Solicitation Addendum

Addendum No.:	2
Solicitation No.:	IFBC19-TA003100SAM
Project No.:	6091680
Solicitation Title:	SWWRF & SEWRF Belt Filter Press Rehabilitation
Addendum Date:	August 29, 2019
Procurement Contact:	Sherri Meier

ELECTRICAL
INSTALLATION DETAIL SHEET 3
(PARTIAL DRAWING)

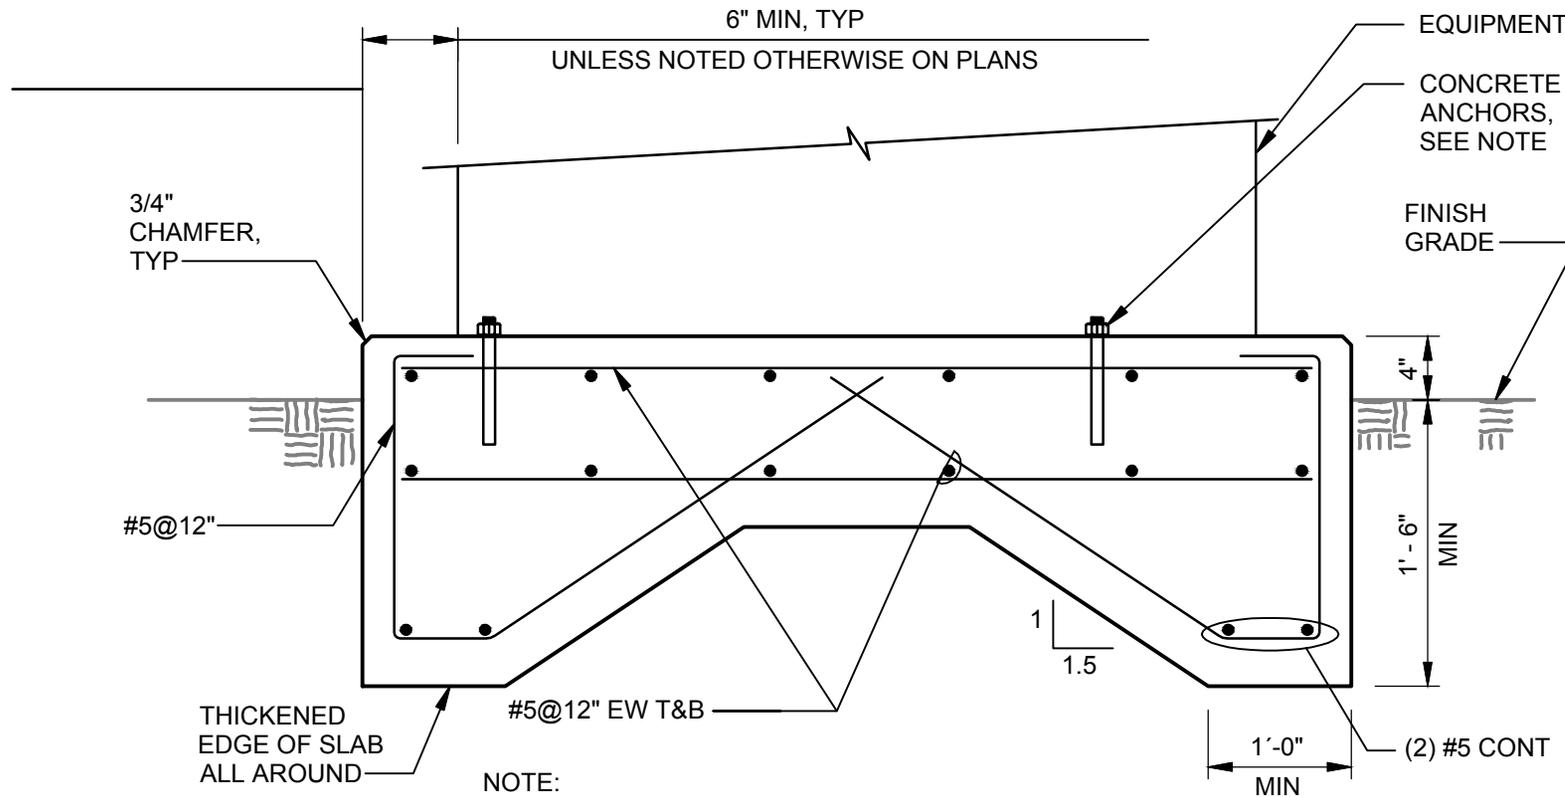
Q2. On sheet E-00-612, XFMR T-7 and XFMR T-8 show pad mounted. Note 9 say wall mount. Please advise. If pad mounted is what is required, is the GC to install the pad and if so, is there a detail?

R2. For Drawing e-00-612, key note 9 applies to xfmr-dw1 30 kva only. **ADD** – key note 15: provide concrete pad for pad mounted transformer xfmr t-7 and xfmr t-8 per detail g, partial drawing e-00-006 (rev.1) attached. Replace – key note 9 with keynote 15 for xfmr t-7 and xfmr t-8.
